72+COLLINS HOTEL & CONDOMINIUM

CITY OF MIAMI BEACH DESIGN REVIEW BOARD

FEBRUARY 2, 2021

ELEVATION NORTH CORNER FACADE - PHASE 2

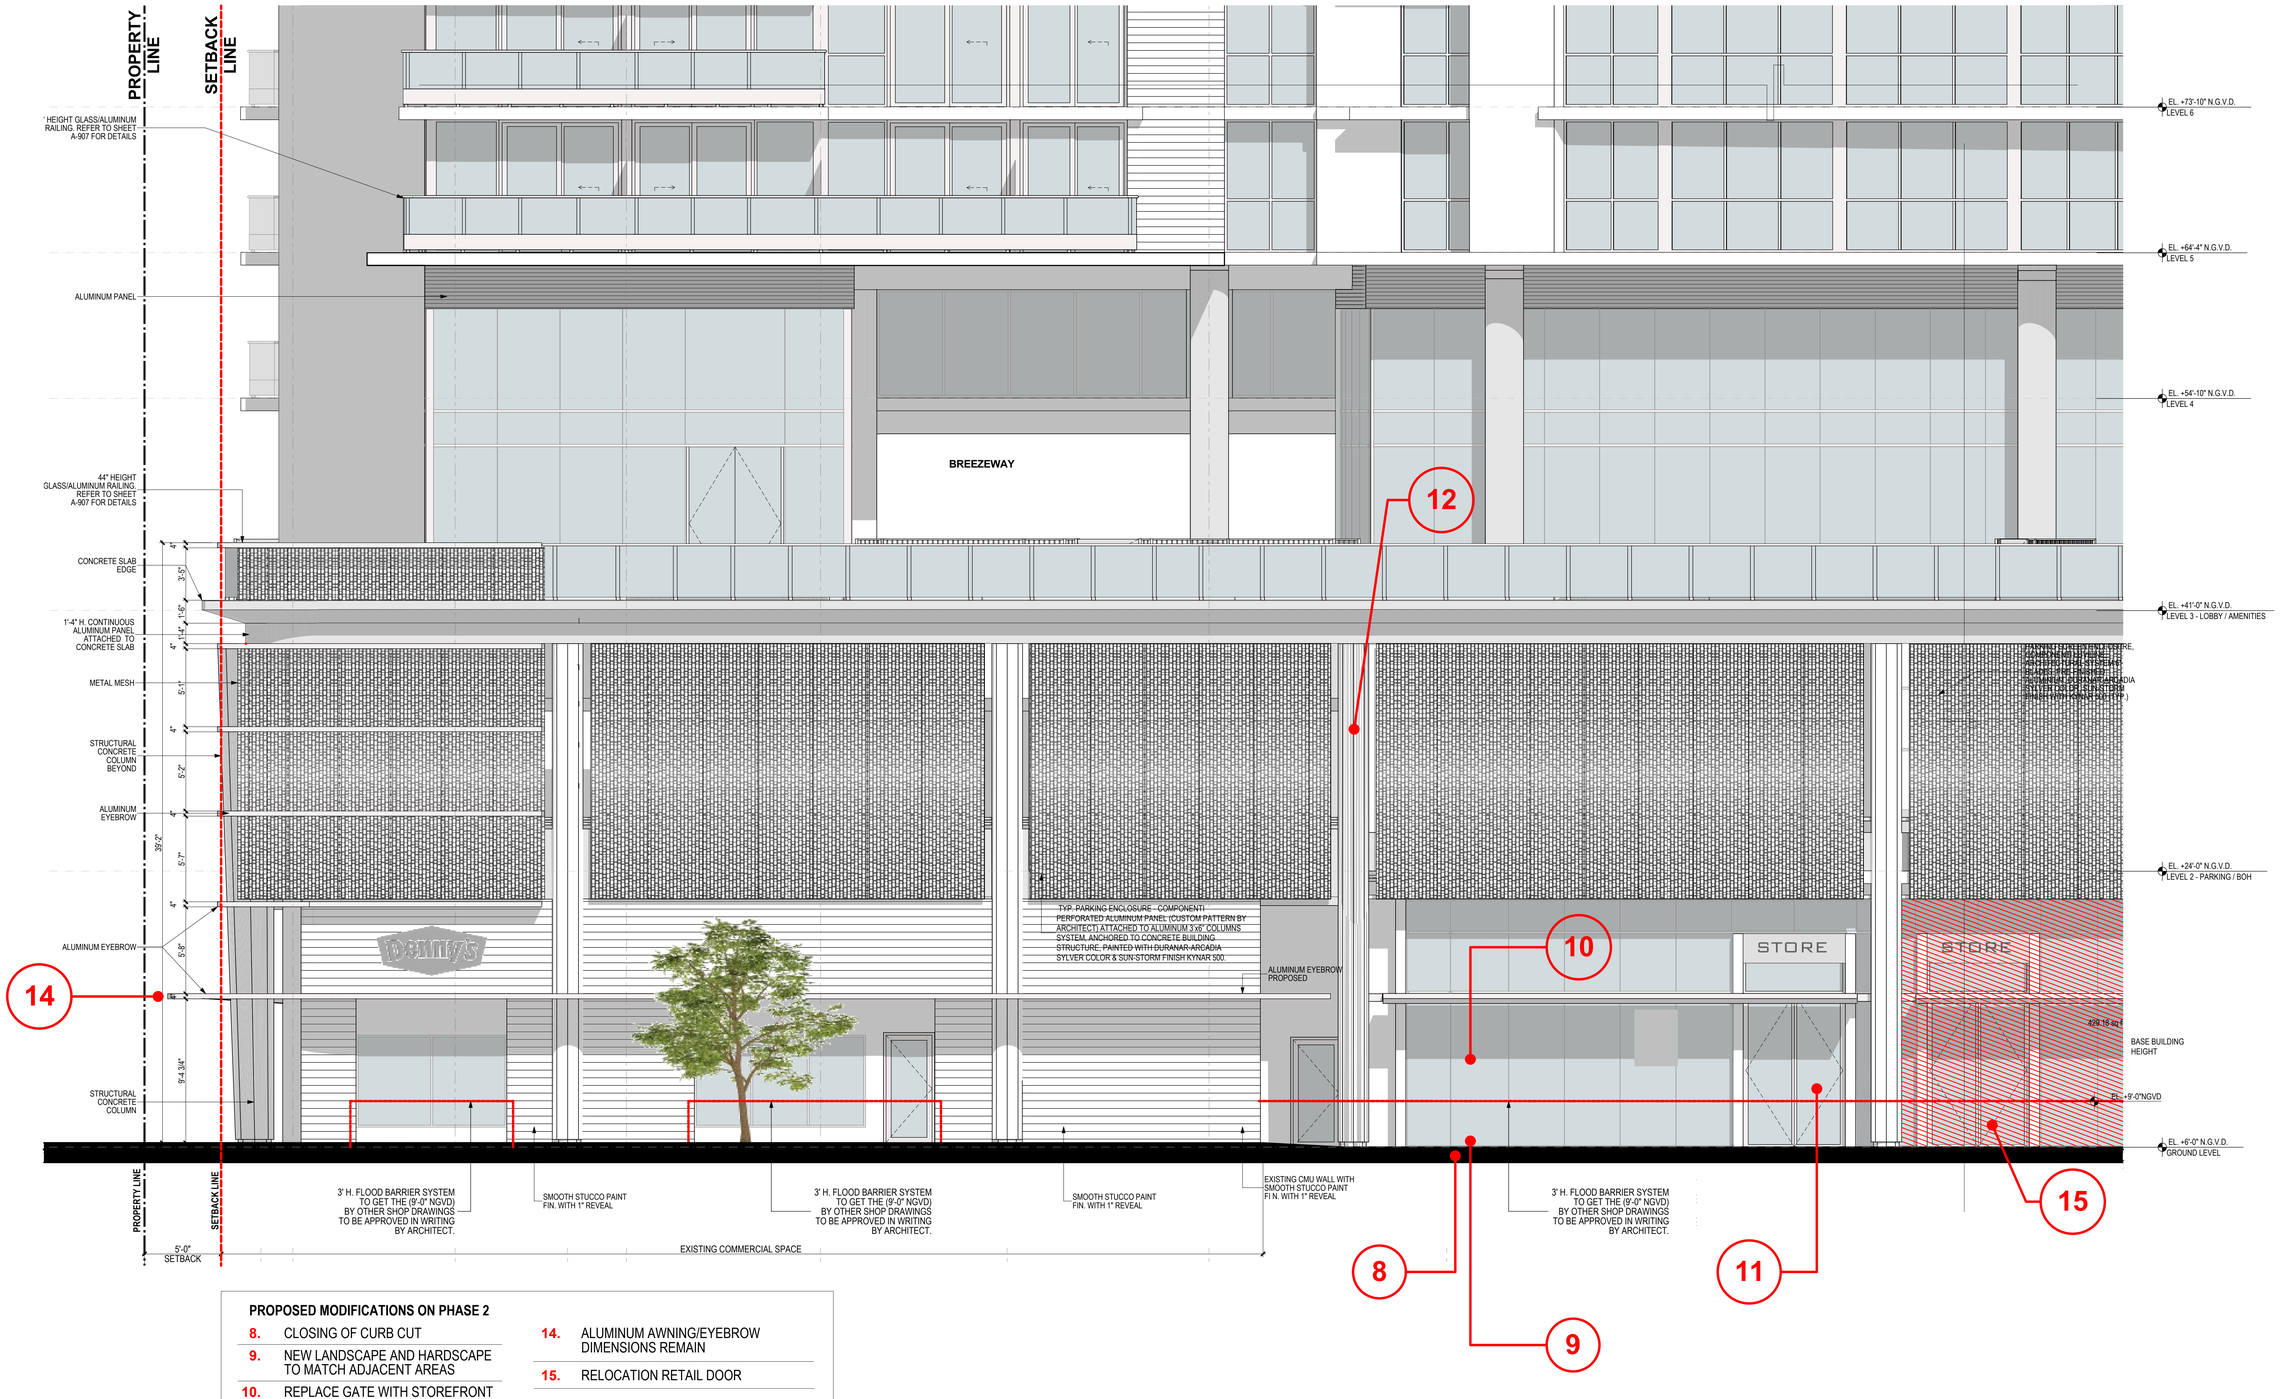
PROPOSED MODIFICATIONS ON PHASE 2

8.	CLOSING OF CURB CUT
9.	NEW LANDSCAPE AND HARDSCAPE TO MATCH ADJACENT AREAS
10.	REPLACE GATE WITH STOREFRONT
11.	INSTALL NEW RETAIL DOOR
12.	COLUMN REMAIN IN THIS LOCATION
13.	COMPLETION OF RETAIL SPACE
14.	ALUMINUM AWNING/EYEBROW DIMENSIONS REMAIN
15.	RELOCATION RETAIL DOOR

ELEVATION EAST CORNER FACADE - PHASE 1

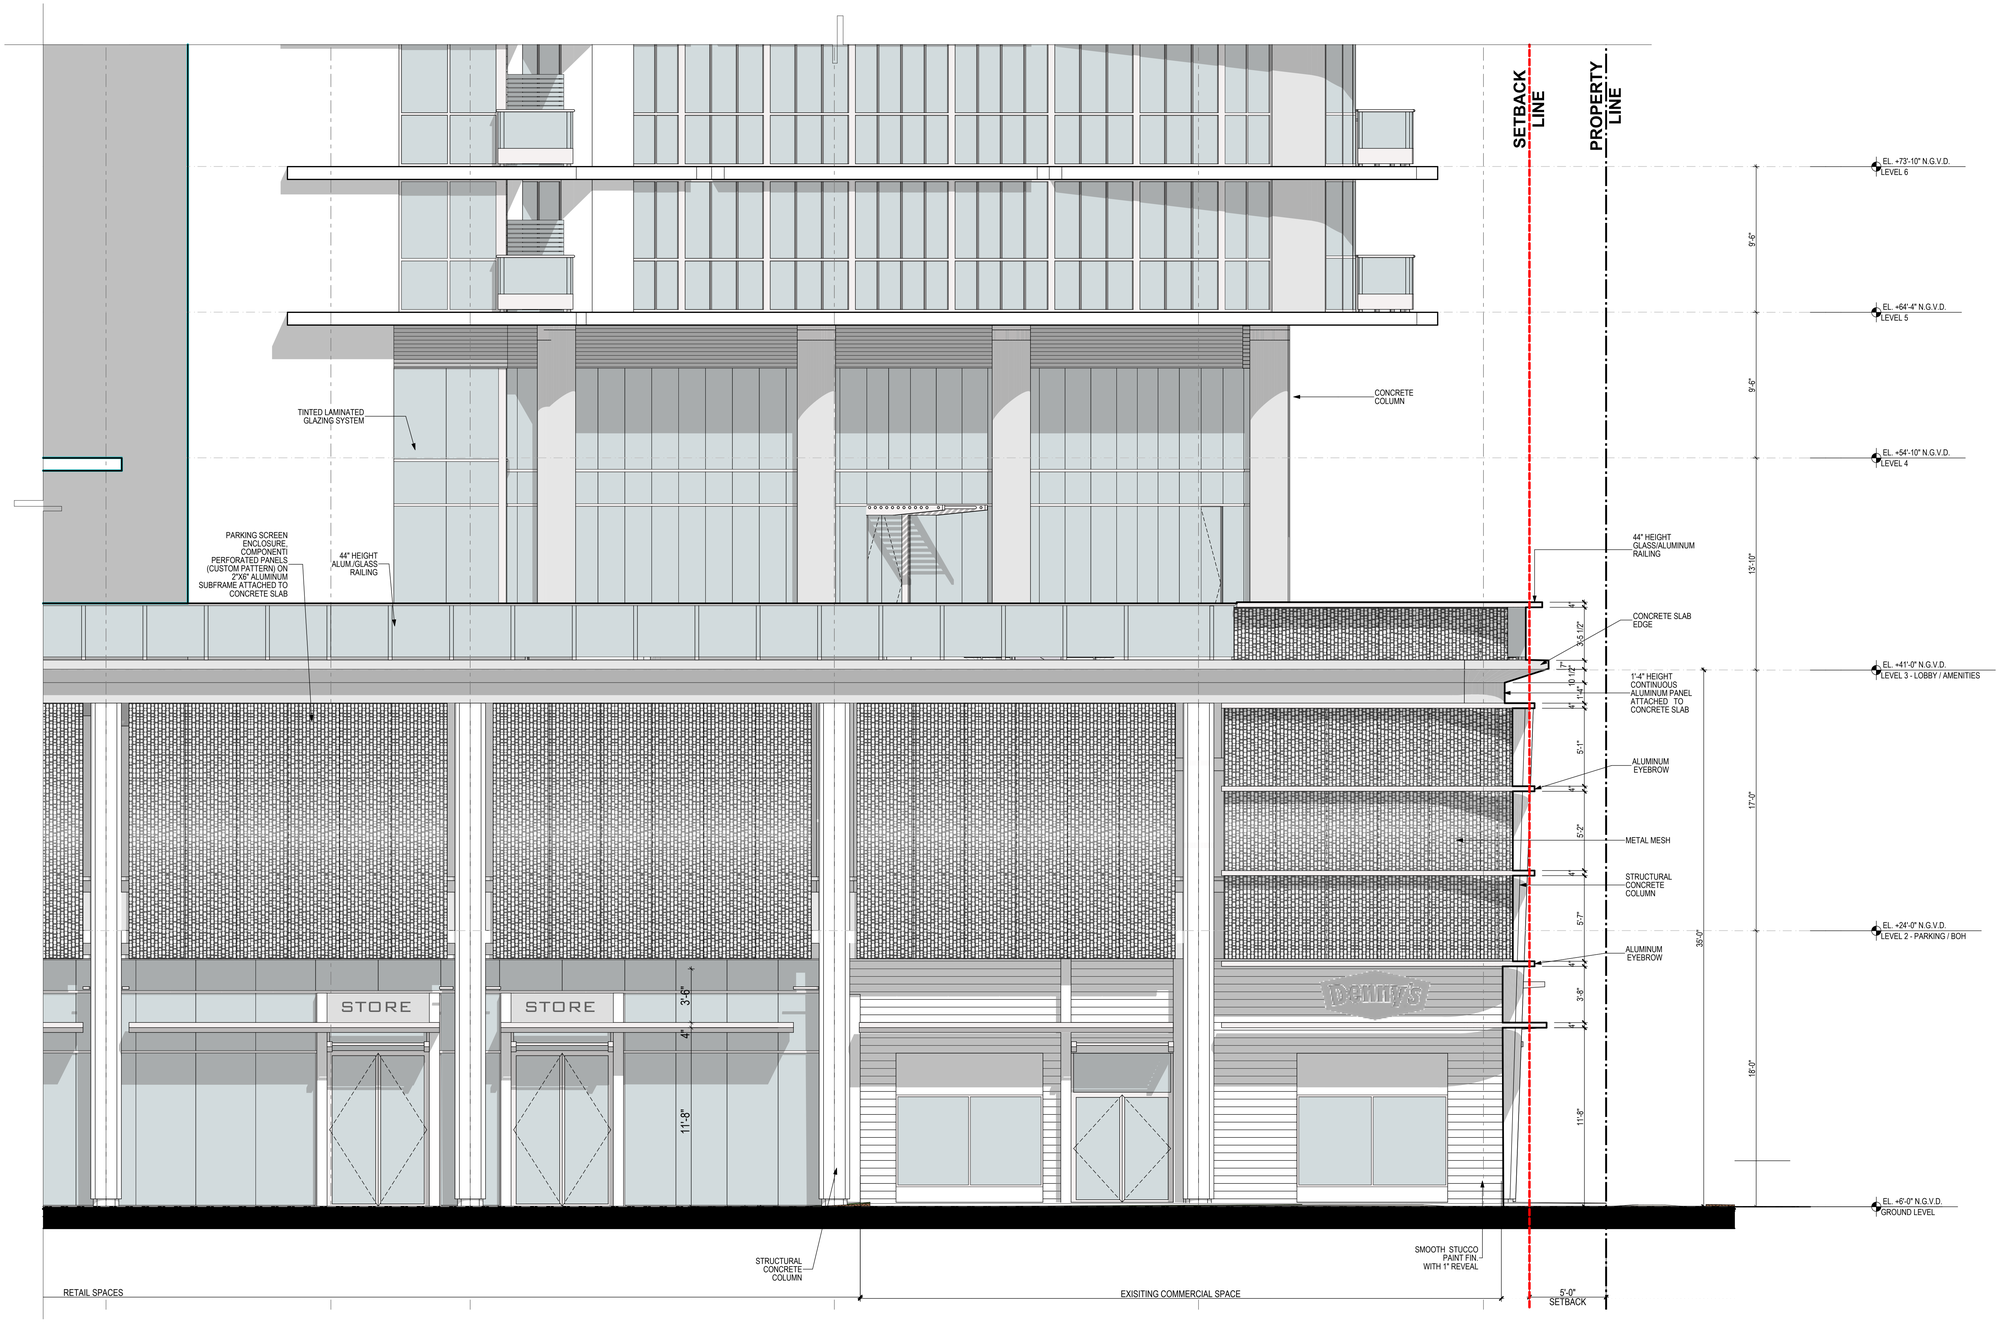
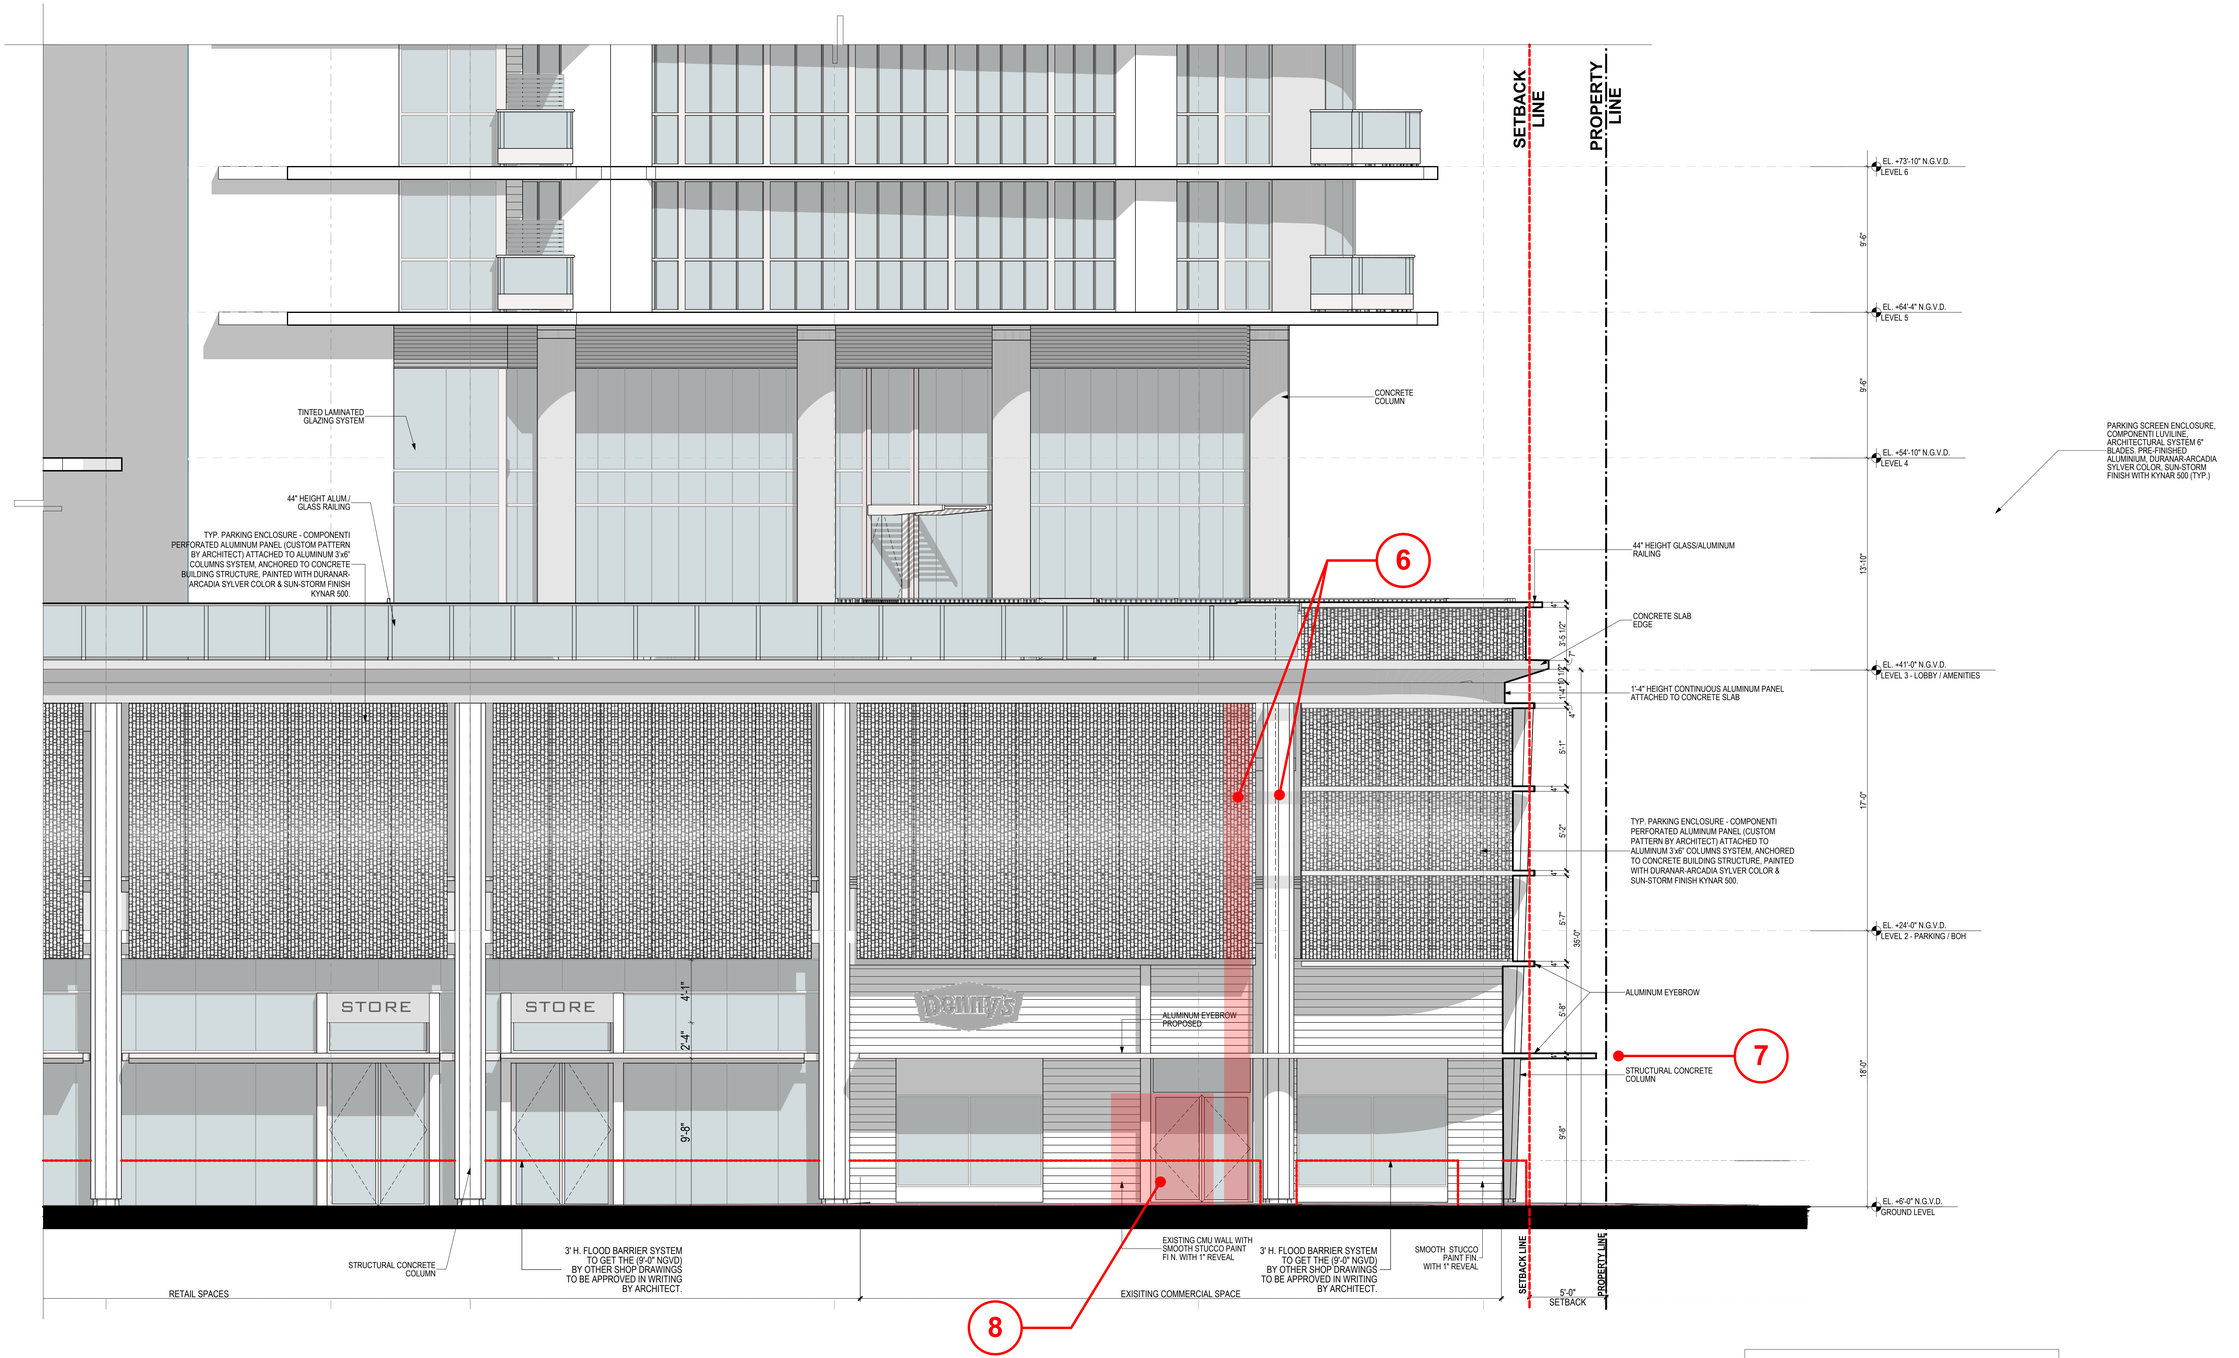
PROPOSED MODIFICATIONS ON PHASE 1

6.	COLUMN RELOCATION
7.	ALUMINUM AWNING/EYEBROW EXTENDED TO MATCH FOOTPRINT OF EXISTING CONSTRUCTED AWNING
8.	RETAIL DOOR RELOCATION
